28 March 2019

Our ref: 3137090-67756
Your ref:

Drouin WWTP works approval support Responses to EPA Request For Additional Information

Figure 2 – Mixing zone distances under low flow conditions in Shillinglaw Ck

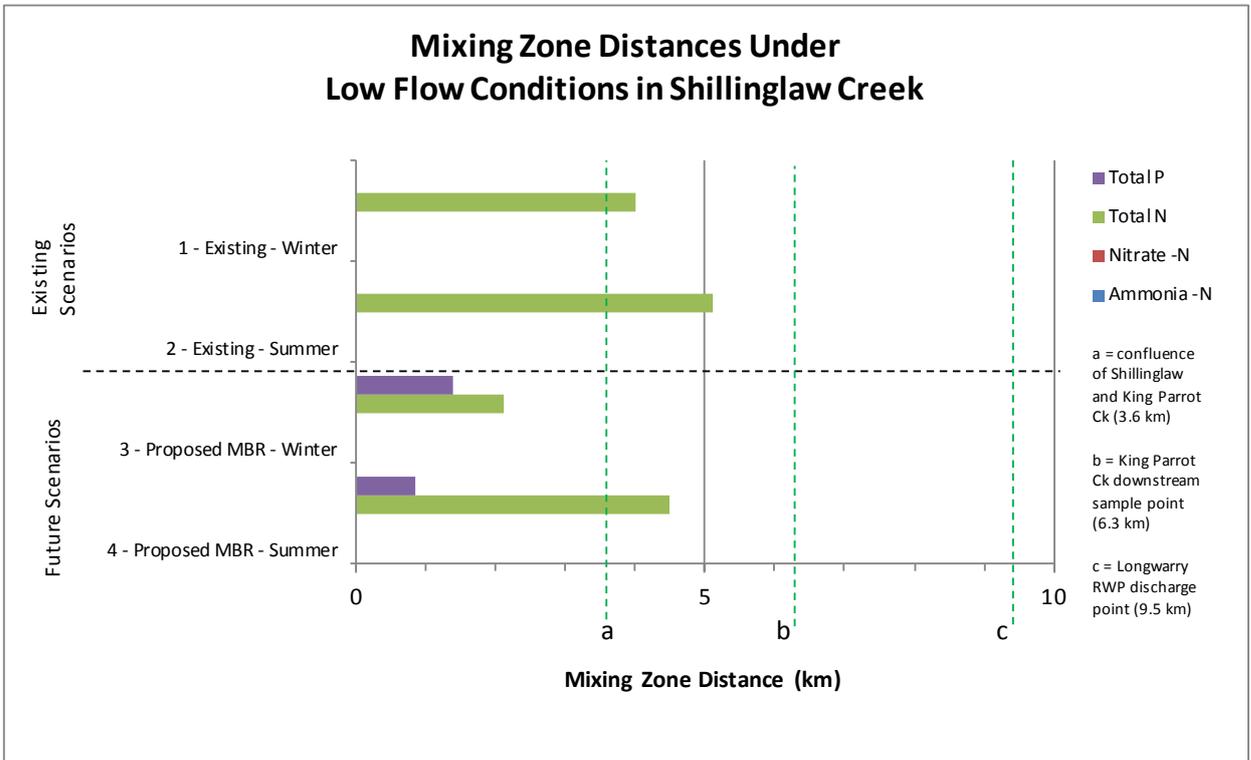
4. *The proposed mixing zones are extensive. Furthermore, it is suggested that "compliance of future Drouin WWTP discharges into Shillinglaw and King Parrot Creeks may be best managed by applying a revised mixing zone into the licence. A drawing of the proposed mixing zone will be negotiated with the EPA following commissioning of the MBR." The extent of the mixing zone should be understood, including forecast discharge growth into the future, and agreed as part of the Works Approval process.*

Mixing zone estimates under low flow and median flow conditions are presented below for four separate scenarios: existing treatment during summer and winter, and proposed MBR treatment during summer and winter. Under current discharge volumes and SEPP (Waters) guidelines, the modelling indicates that the proposed MBR treatment will reduce total mixing zone distance.

The mixing zone has been re-assessed with updated values for ammonia toxicity, total N and total P under 2030 population scenario. The mixing zone for ammonia is now considered to be essentially non-existent - previous calculations were too conservative. Total N and total P mixing zones are reduced from the previous reports as SEPP guideline concentrations have increased compared to the previous SEPP. A discharge regime during winter will be also reduce the mixing zones as higher dilution will be available. A mixing zones overview is presented above.

Figure 4 - Mixing Zone map, showing sampled water quality (Nitrate-N) in Shillinglaw Creek.

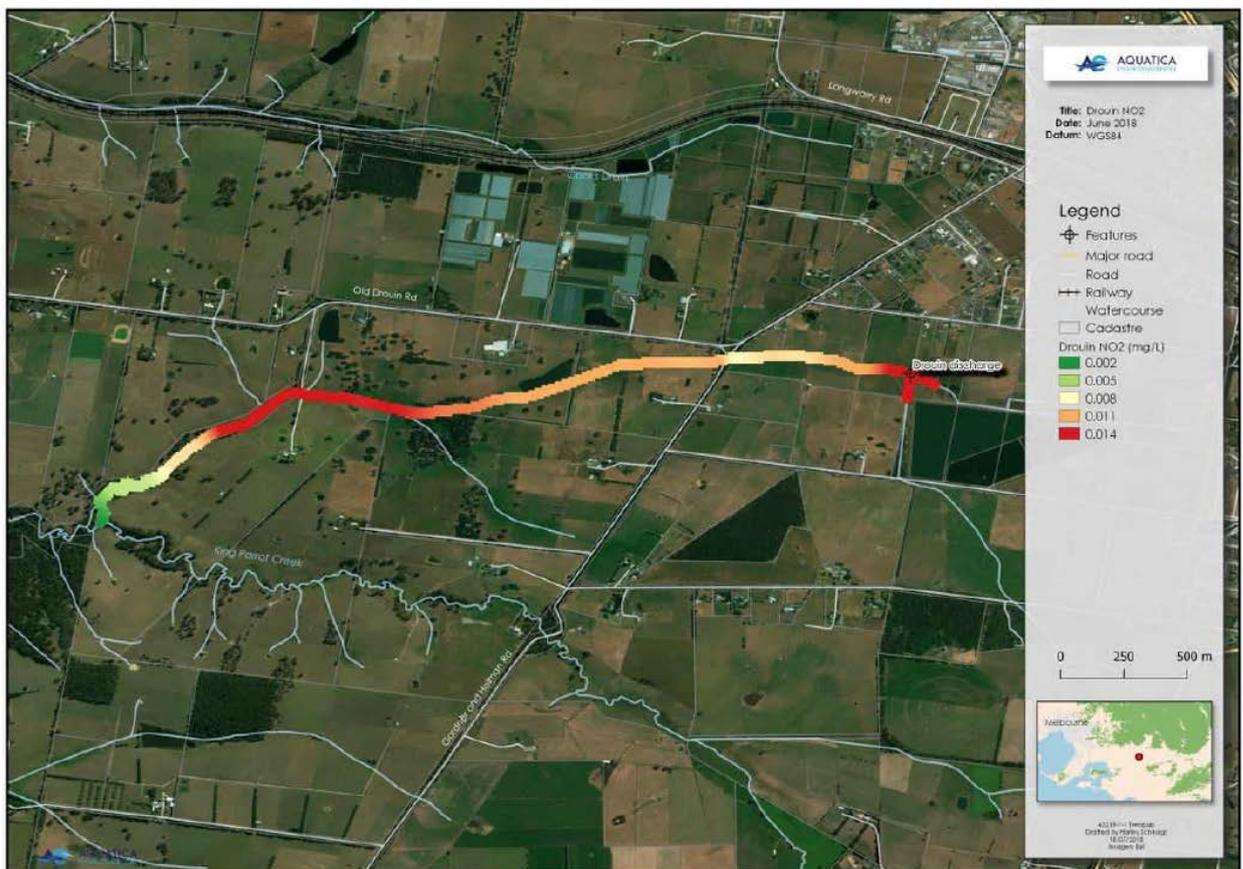
- Provide an approach to improving mixing zone over time, reasons why or why not this is not possible, but using monitoring of RBA to show risk is managed.

Recent mixing zone mapping highlighted several sources of water quality impacts from agricultural land downstream of Drouin WWTP. Figure 4 provides an example for nitrate concentrations, that decline downstream of the Drouin WWTP discharge, but also increase to greater concentrations approximately 1.5km further downstream. Opportunities exist for Gippsland Water to help manage these sources, resulting in a net benefit to the waterway conditions. The protection of instream vegetation downstream of the discharge location is one measure that will enhance ecosystem services that provide benefits to downstream ecosystem condition. There are opportunities to enhance aquatic habitat and protect riparian condition, which are expected to improve ecological values and ecosystem condition.
